**TENDER NO: 2025-04**

**Little River Reservoir Beach Volleyball Court**

## **ADDENDUM**

**ADDENDUM NO:** 1

**GATE NOTES:**

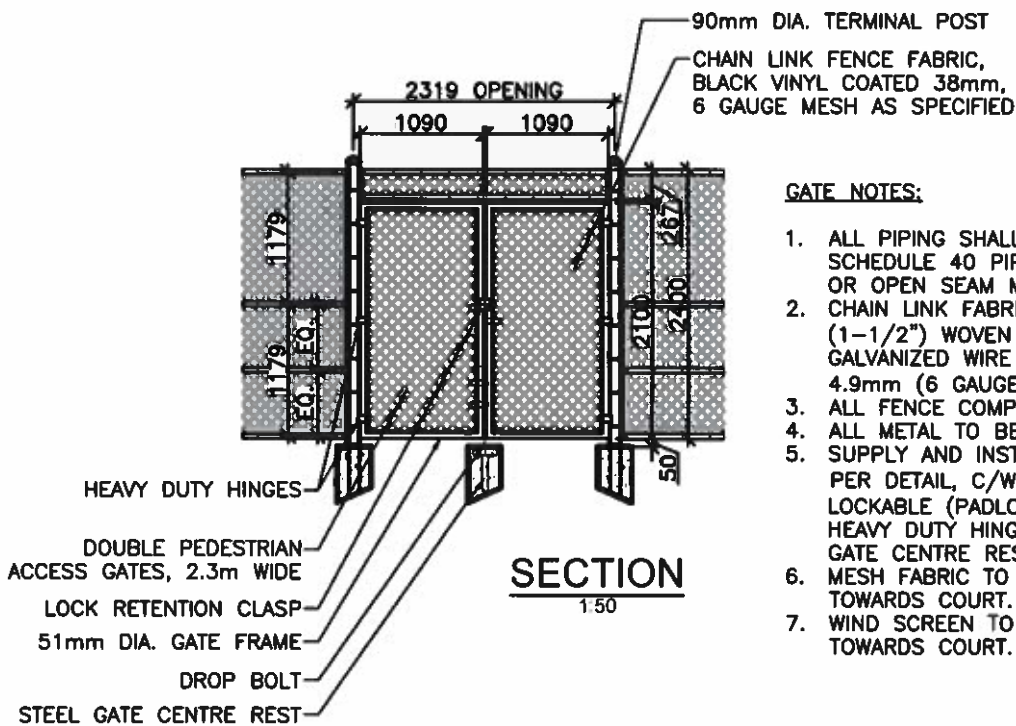
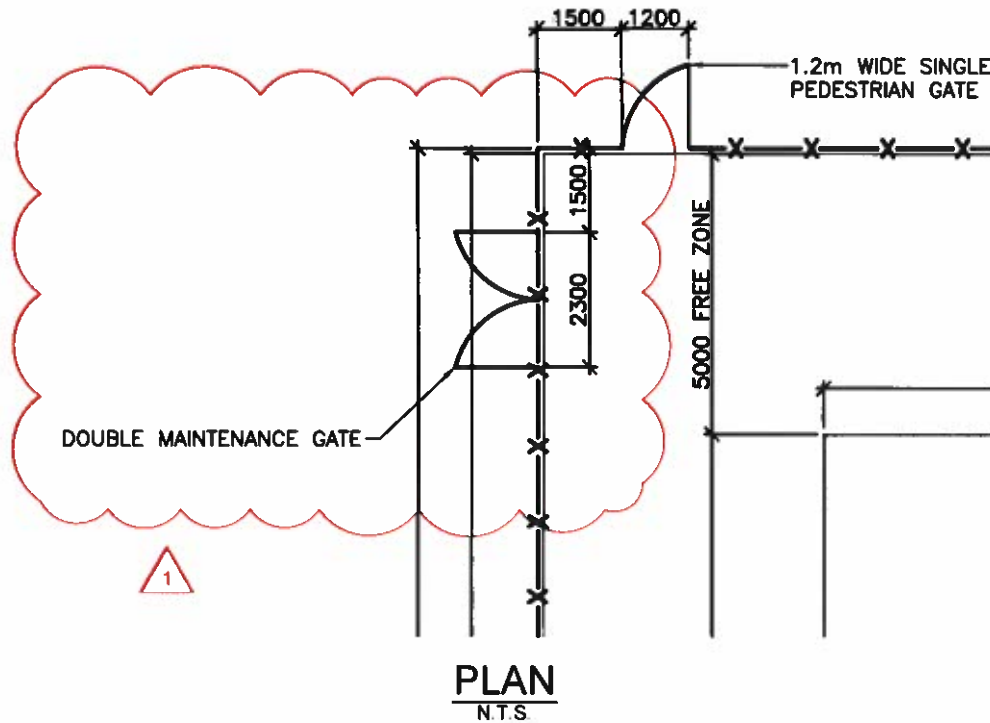
### **ADD SECTION 3.1.21 Vehicle Access Gate**

The Contractor shall install a 2.319m wide Chain Link Maintenance Gate within the 2.4m high Chain Link perimeter fencing of the volleyball court. The exact location of the gate shall be determined in the field by the Engineer.

Refer to the gate detail drawing and the revised Schedule of Quantities and Unit Prices with Addendum #1.

1. ALL PIPING SHALL BE STANDARD CONTINUOUS WELD, SCHEDULE 40 PIPE, GALVANIZED, NO TUBING, CONDUIT OR OPEN SEAM MATERIAL WILL BE PERMITTED.
2. CHAIN LINK FABRIC TO BE BLACK VINYL COATED 38mm (1-1/2") WOVEN MESH OF 4.9mm (6 GAUGE) GALVANIZED WIRE FASTENED TO ALL SUPPORTS WITH 4.9mm (6 GAUGE) GALVANIZED WIRE 300mm O.C.
3. ALL FENCE COMPONENTS TO BE BLACK VINYL COATED.
4. ALL METAL TO BE GALVANIZED.
5. SUPPLY AND INSTALLATION OF MAINTENANCE GATE ENTRY, PER DETAIL, C/W TWO 1.09m WIDE GATES WITH LOCKABLE (PADLOCK) AND SELF-LATCHING MECHANISM, HEAVY DUTY HINGES, AND A DROP BOLT WITH STEEL GATE CENTRE REST SET IN CONCRETE FOOTING.
6. MESH FABRIC TO BE INSTALLED ON INSIDE FACE TOWARDS COURT.
7. WIND SCREEN TO BE INSTALLED ON INSIDE FACE TOWARDS COURT.
